Video Products Technical Bulletin 30-2002-287

DATE: **December 23, 2002**SUBJECT: **VIDEO NOISE WITH BKM-B10 VIDEO INPUT
ADAPTOR BOARD**MODEL: **PFM-50C1
PFM-50C1E**

Figure 1

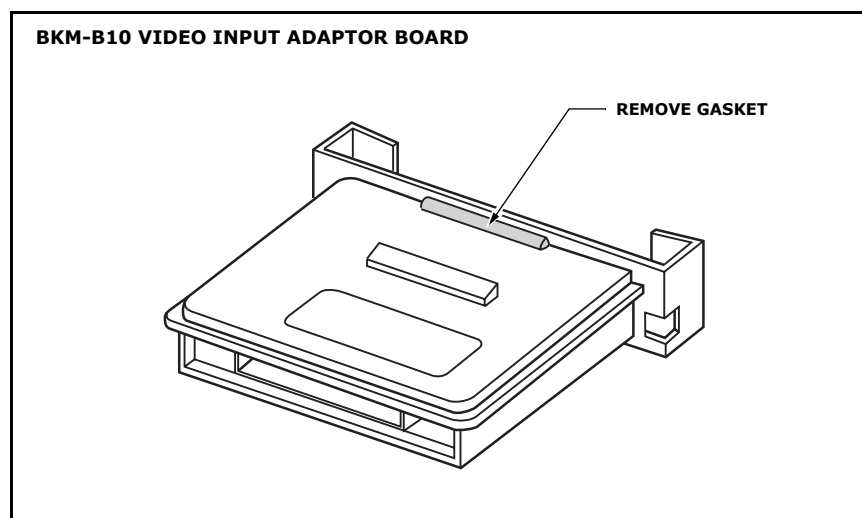
To prevent video noise when using the BKM-B10 video input adaptor board, remove the gasket from the BKM-B10 board. (See Figure 1.)
